RANCHO SANTIAGO COMMUNITY COLLEGE DISTRICT

ADDENDUM NO. 2

Bid #1506
ORANGE EDUCATION CENTER PORTABLES PHASE II
at
ORANGE EDUCATION CENTER

Project ID #3762, DSA #04-125366

3 WAYFINDING SIGN 03
Scale: 3" = 1'-0"

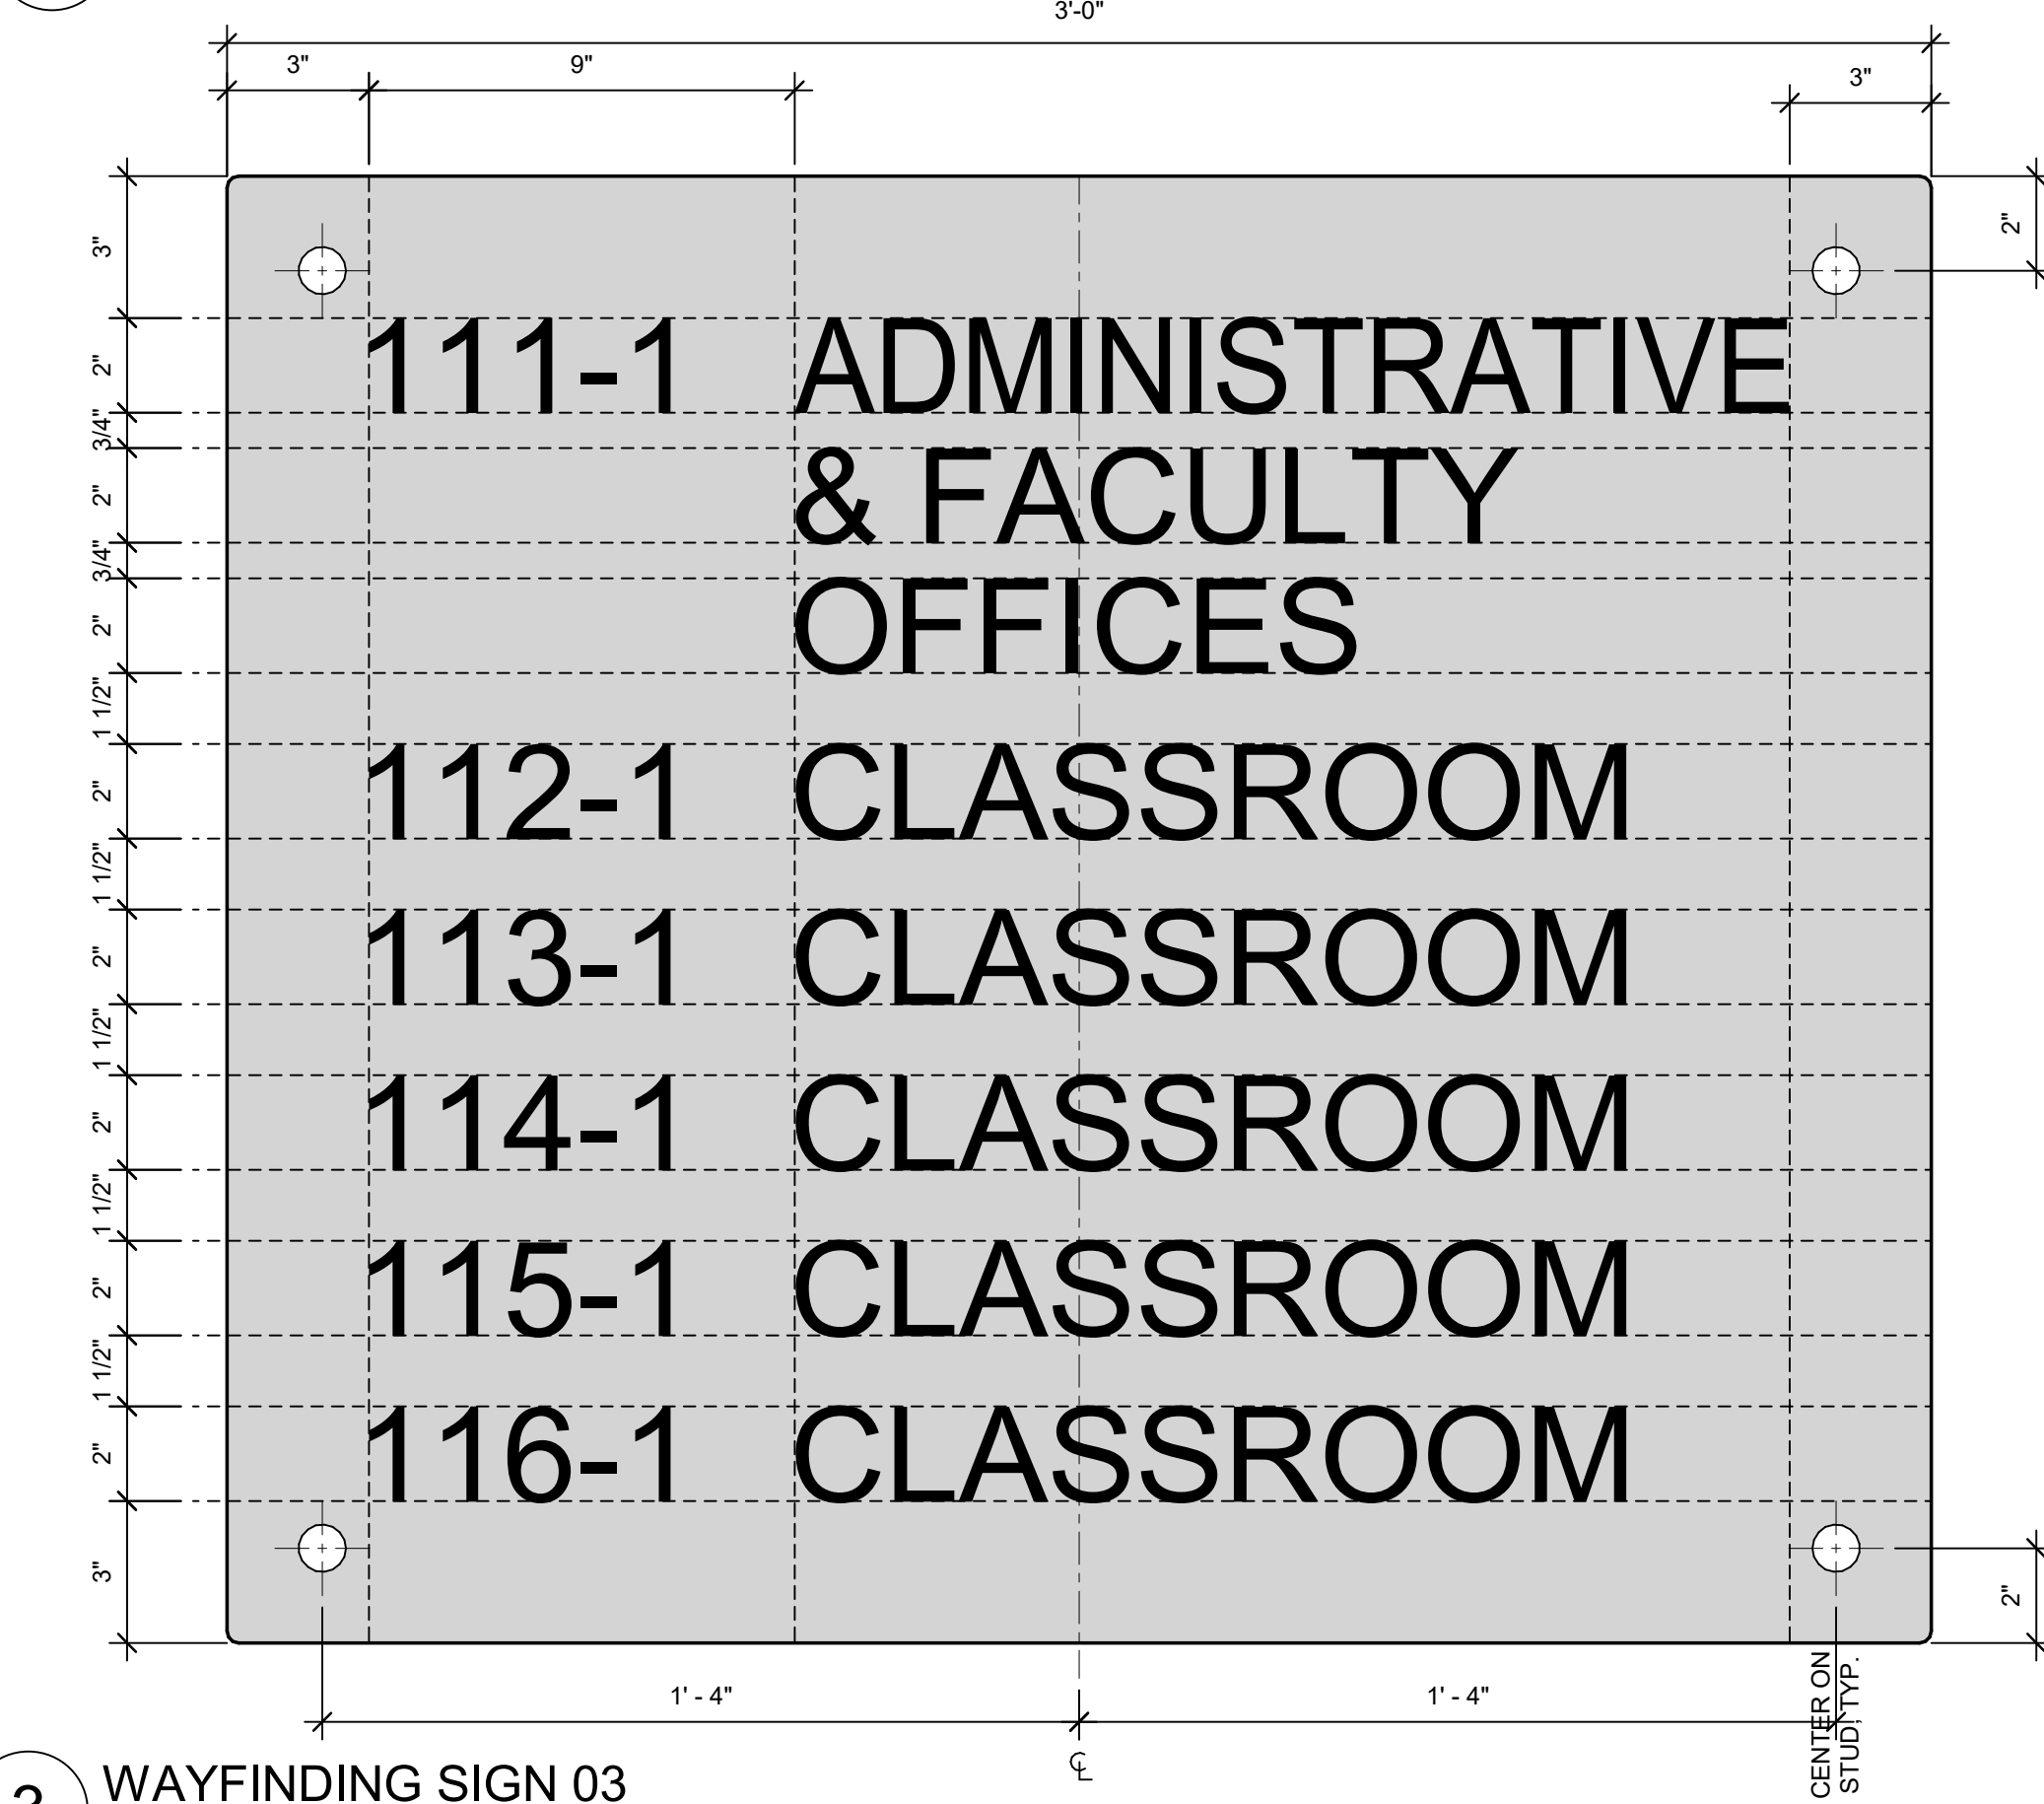
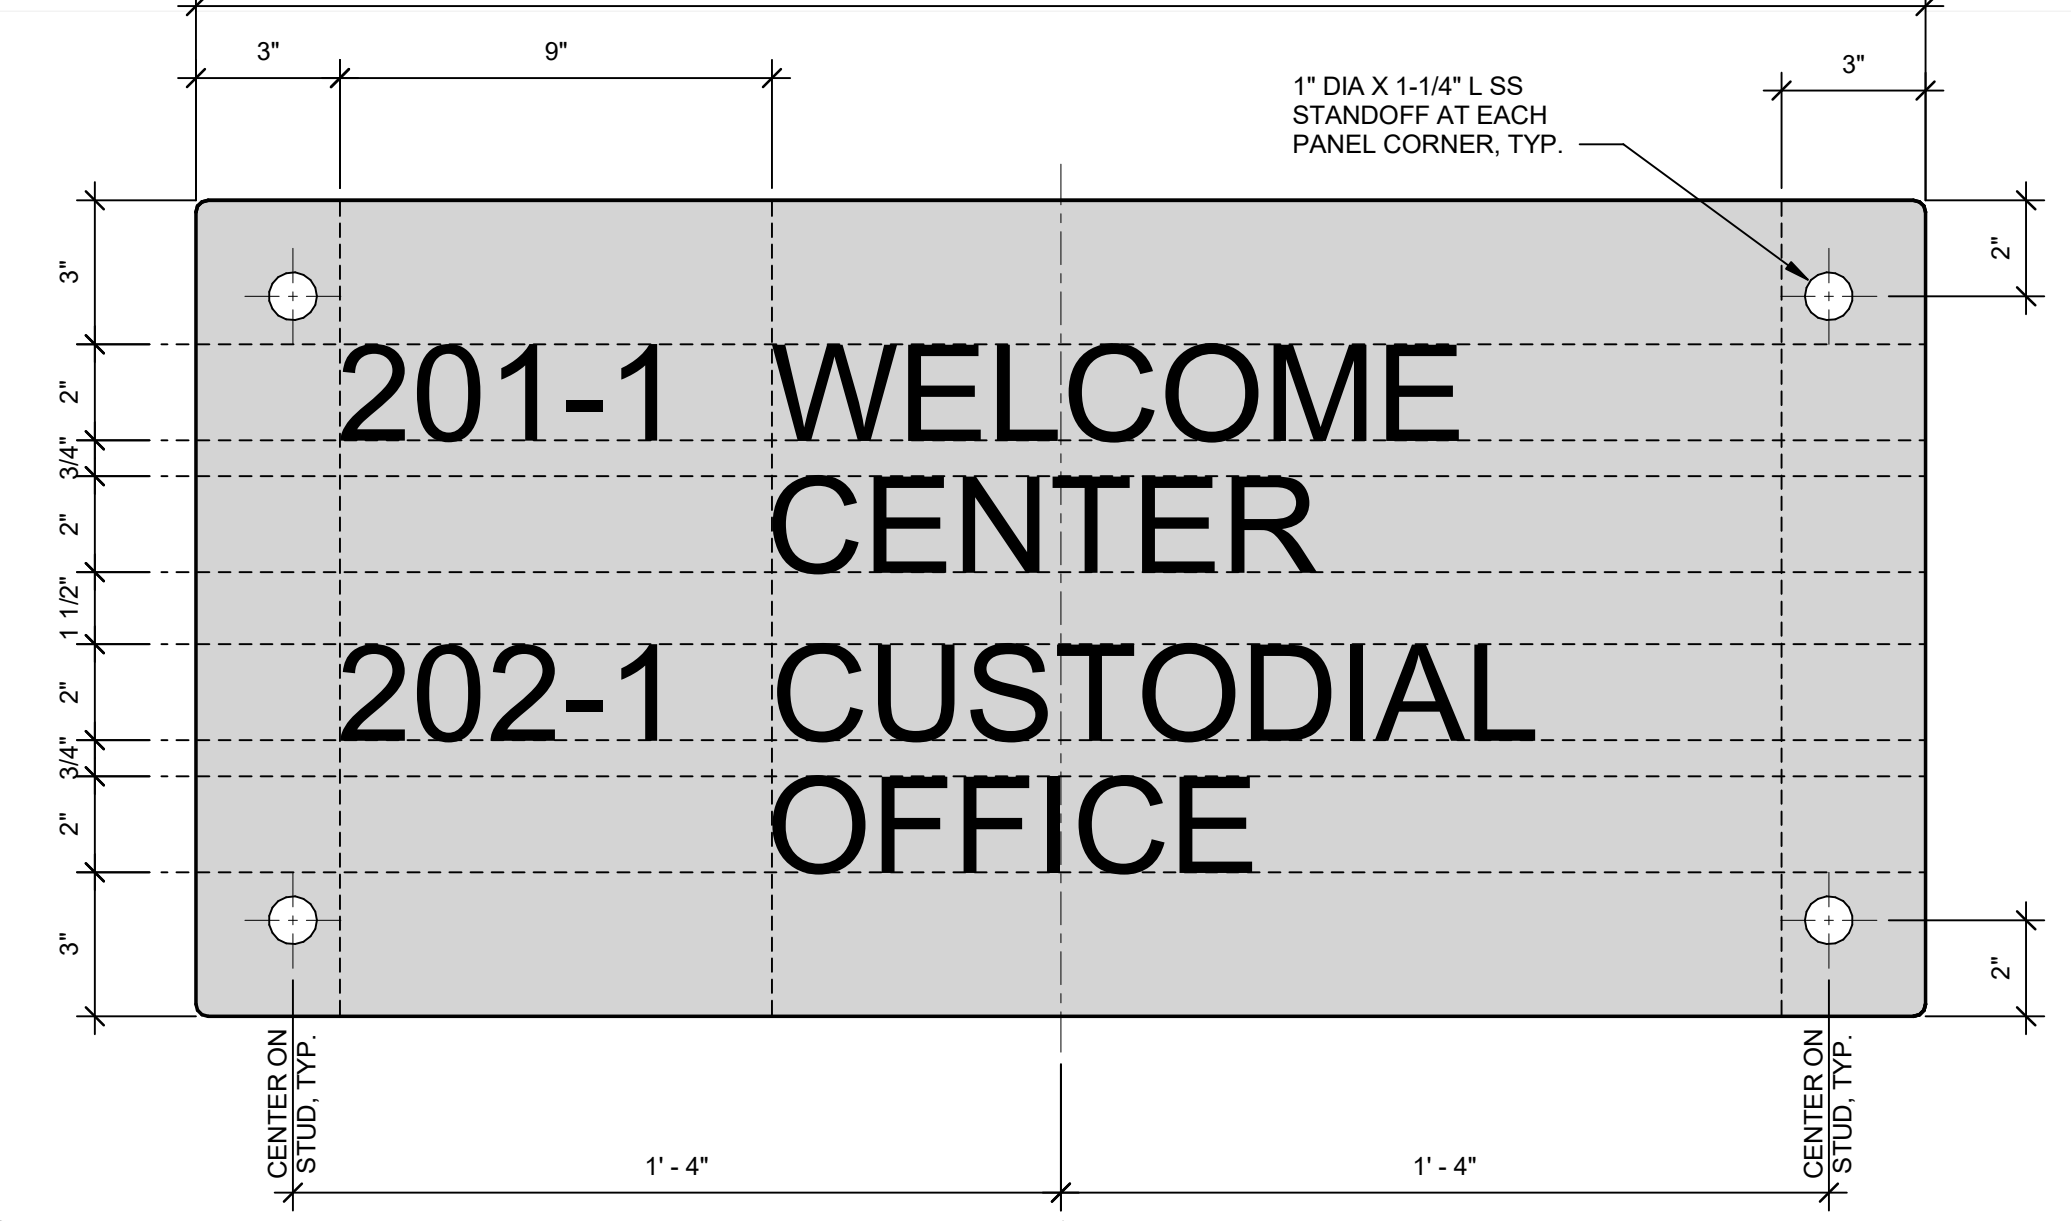
6. A6.02-2, WAY FINDING SIGNAGE DETAILS

Added Addendum Dwg. A6.02-2, Way Finding Signage Details
